# PLANNING COMMISSION MEETING AGENDA REGULAR MEETING

5. PUBLIC HEARING – SPECIAL USE REQUEST AND PRELIMINARY SITE PLAN REVIEW (File Number SU 395) – Proposed Kroger Retail Fuel Center, West side of Rochester, South of Long Lake (4889 Rochester Road), Section 15, Currently Zoned NN “L” (Neighborhood Node “L”) District

## Site Plan Review For City of Troy, Michigan

KROGER D-487
RETAIL FUEL CENTER
4889 ROCHESTER ROAD at E. LONG LAKE ROAD
TROY, MI 48085
COVER SHEET

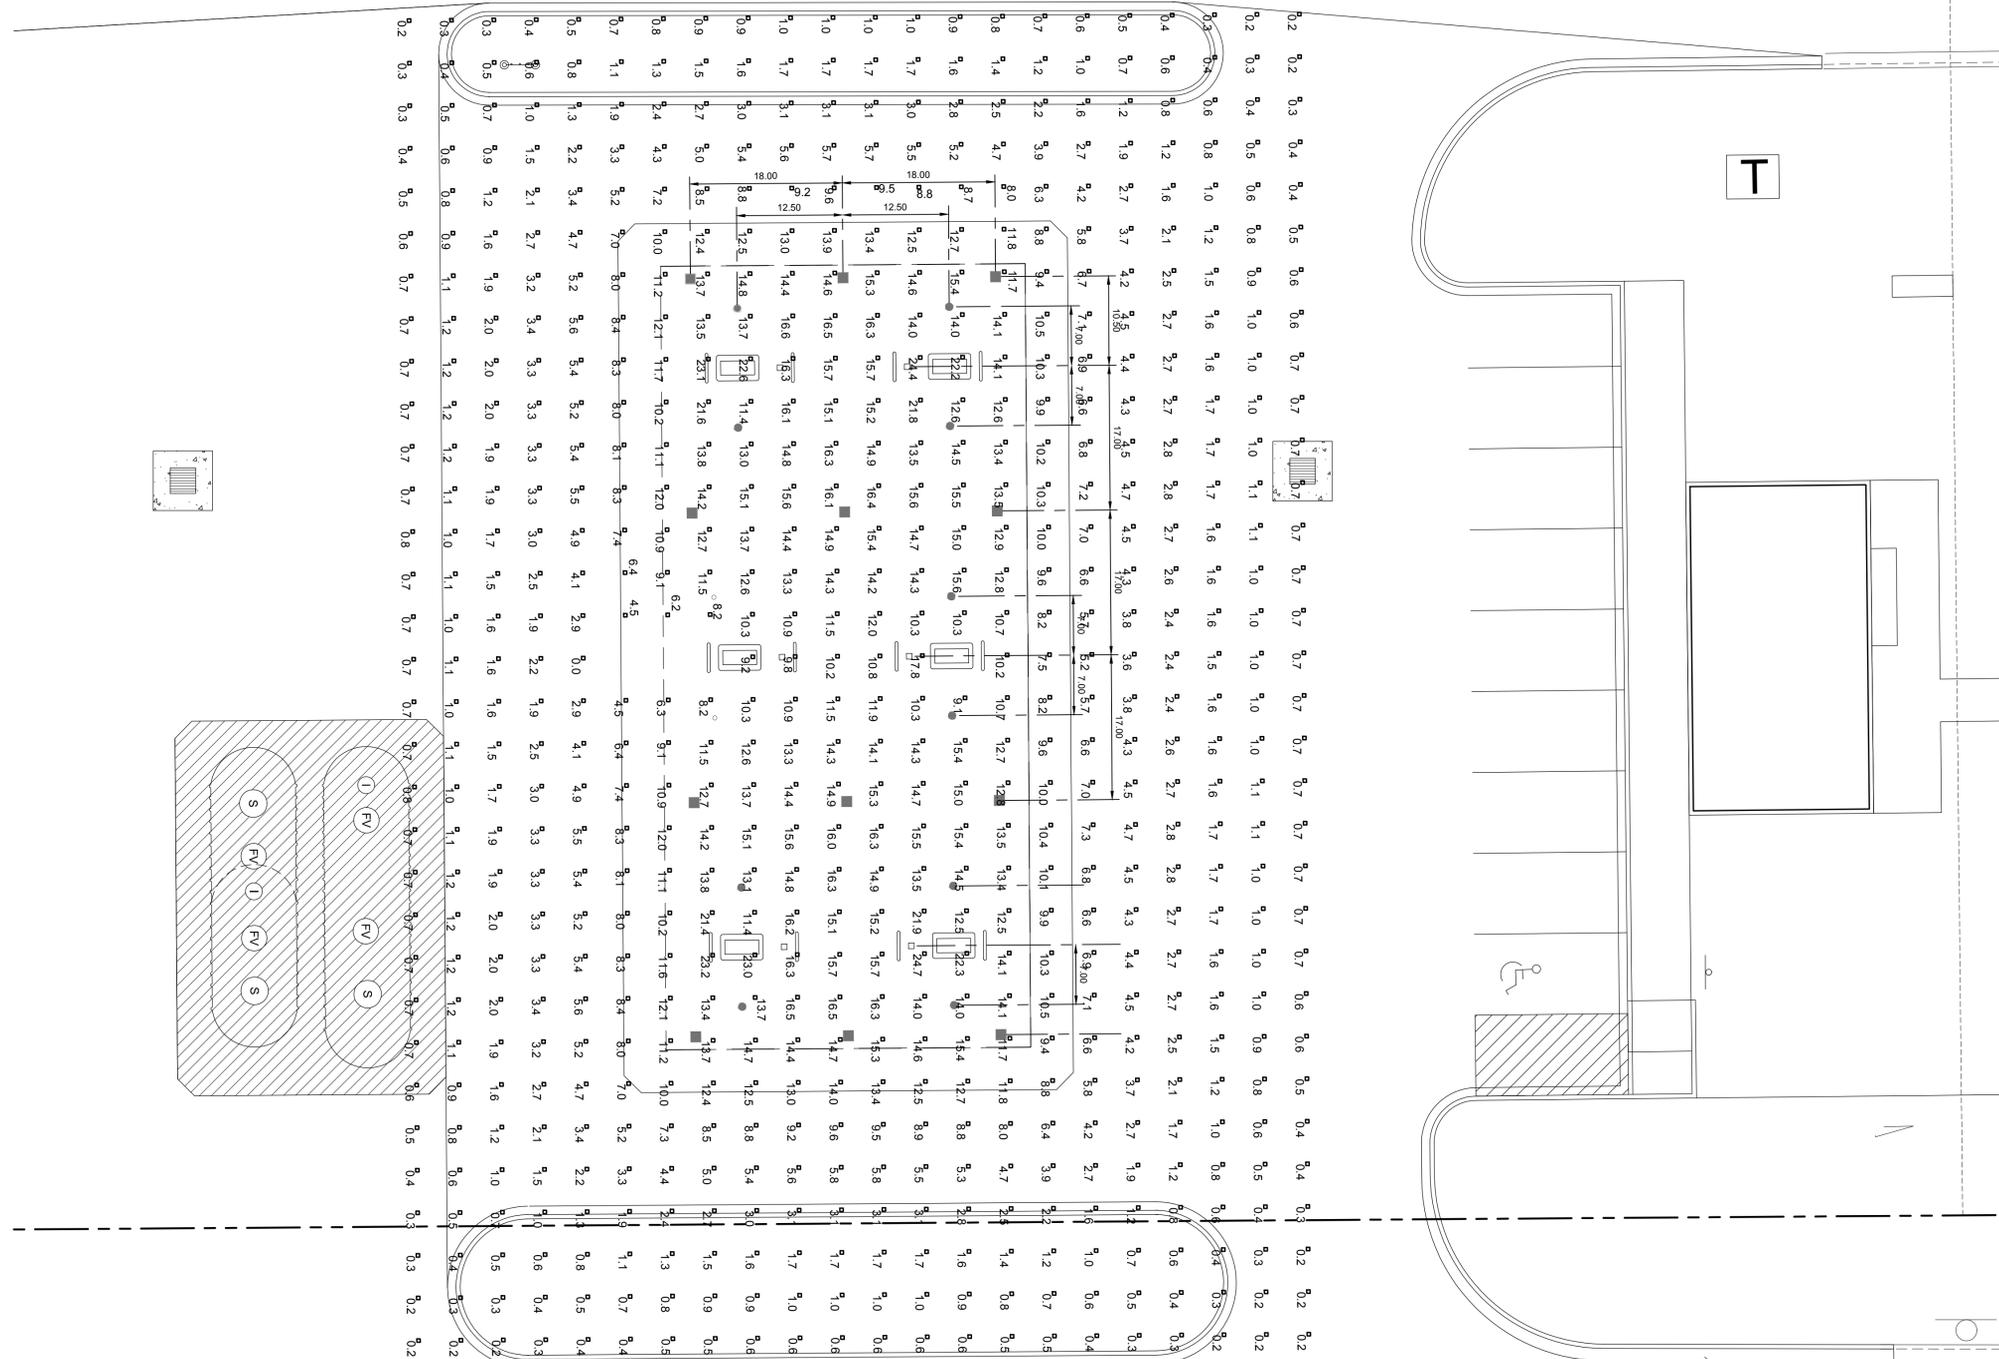
The applicant has provided a lighting (photometric) plan. The applicant shall reduce the maximum lighting under the canopy to no greater than 20 foot candles. Furthermore, the applicant shall turn-off or reduce lighting between the hours of 11:00 p.m. and sunrise

SHEET NO.  
**L-100**

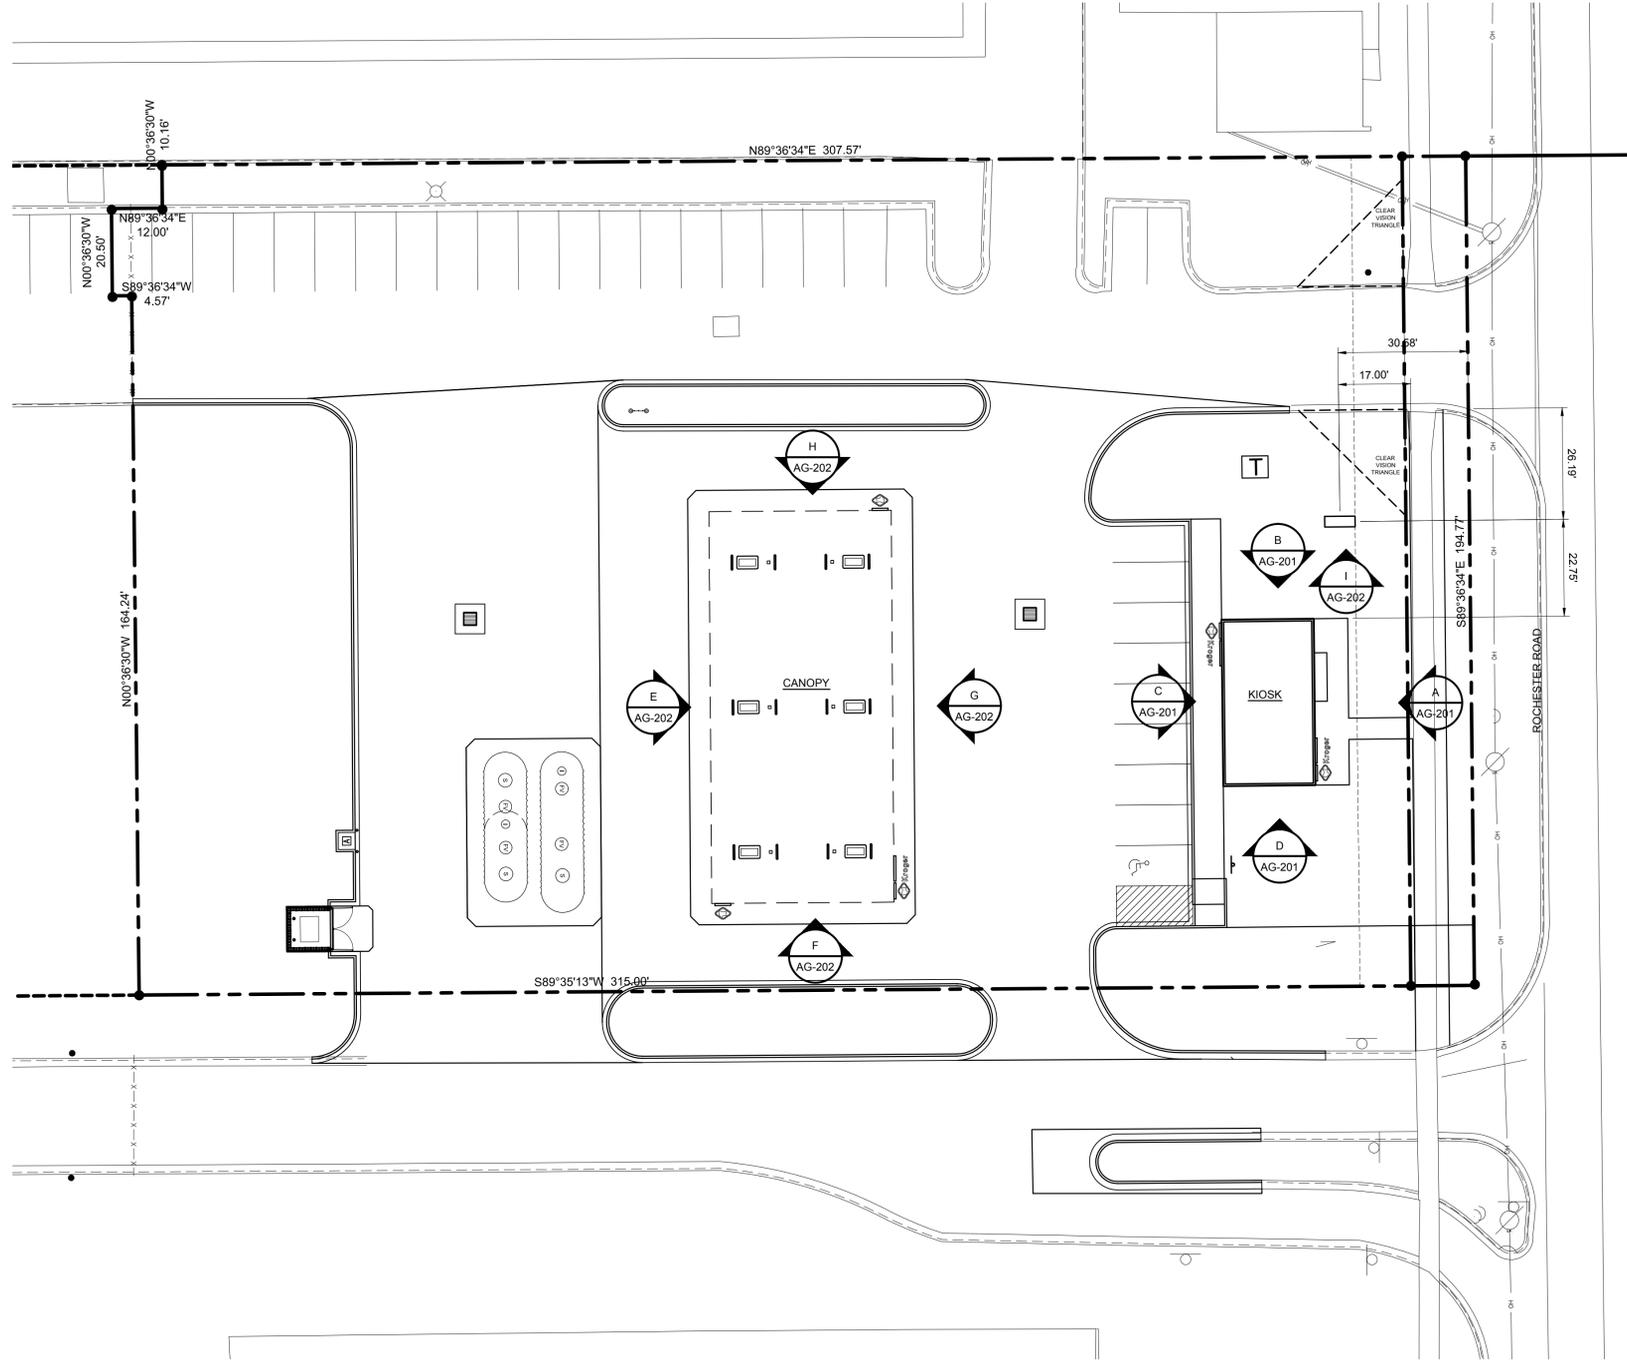
The Ordinance requires that the greenbelt shall be landscaped with a minimum of one (1) deciduous tree for every thirty (30) lineal feet, or fraction thereof, of frontage abutting a public road right-of-way. This site has 194 feet of frontage on Rochester, requiring six (6) trees. However the applicant has only provided five (5) trees within the Rochester Road greenbelt. An additional deciduous street tree must be added to meet minimum Ordinance requirements for Rochester Road.

**Items to be Addressed:** 1.) Add at least one (1) street trees on Rochester Road; and 2.) Provide an agreement with the adjacent east property owner regarding ongoing detention area maintenance.

- a. Add one deciduous street tree on Rochester Road
- b. Provide an agreement with the adjacent east property owner regarding ongoing detention area maintenance.

## Pedestrian Walkthrough Potential Considerations

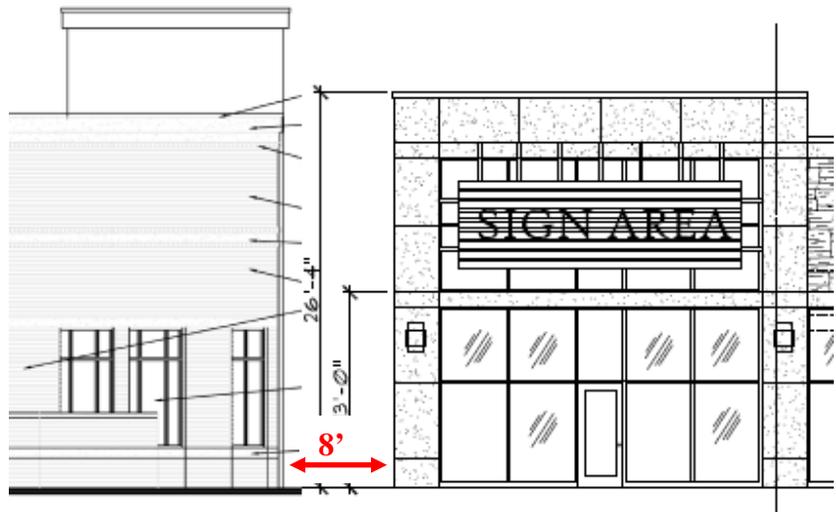
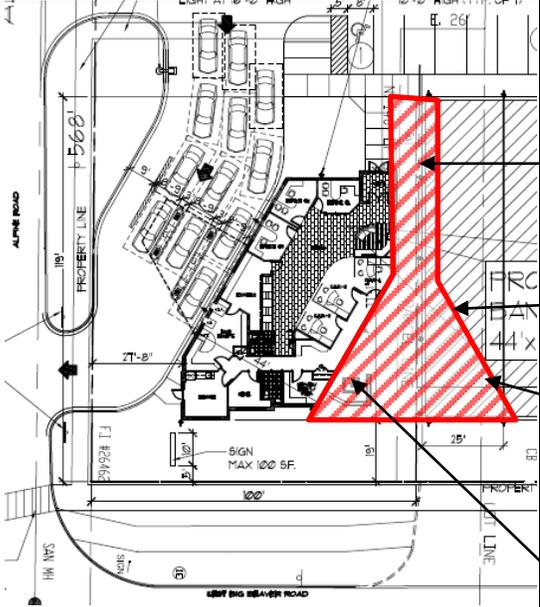
We applaud the applicant for placing the building along Big Beaver to create a presence and human-scale streetscape along the street. This building placement carries on the vision of the future redevelopment of Big Beaver Road. However, the proposed building is underwhelming as to what is envisioned and intended for this site. This is a key site to the development and redevelopment opportunities along Big Beaver Road, and specially the areas between Crooks Road and Coolidge Highway. As such, the site should have more intensity and massing. While a 10-12 story building in height for this site, as noted in the Big Beaver Corridor Study might not be feasible due to market restrictions, a building with more intensity and massing than proposed is desired. A multiple story building along Big Beaver is preferred. The applicant should note what market restrictions exist that would prohibit the construction of a multiple story building. If a one-story building is the only feasible development option for this site, the applicant should find ways to incorporate more massing and scale in order to provide a greater street presence.

The bank and retail building are separated via a pedestrian walkthrough corridor that allows customers to gain access to the parking lot from Big Beaver and vice versa. The orientation, connection, and architectural consistency between the bank building and retail building should be reviewed.

- Narrowness of walkthrough (8 feet), especially in consideration of height of adjacent retail and bank buildings (26 feet and 31 feet respectively).
- The placement of the bank air conditioning unit and screenwall in “pedestrian” zone that is visible from Big Beaver Road.
- Lack of transparency at southwest corner of retail building might create safety for concerns for pedestrian traveling west bound who must use pedestrian walkthrough between buildings to gain access to the parking lot or rear building entrances.

In order to provide a more inviting pedestrian option from the parking lot to Big Beaver Road and vice versa the applicant should consider the following:
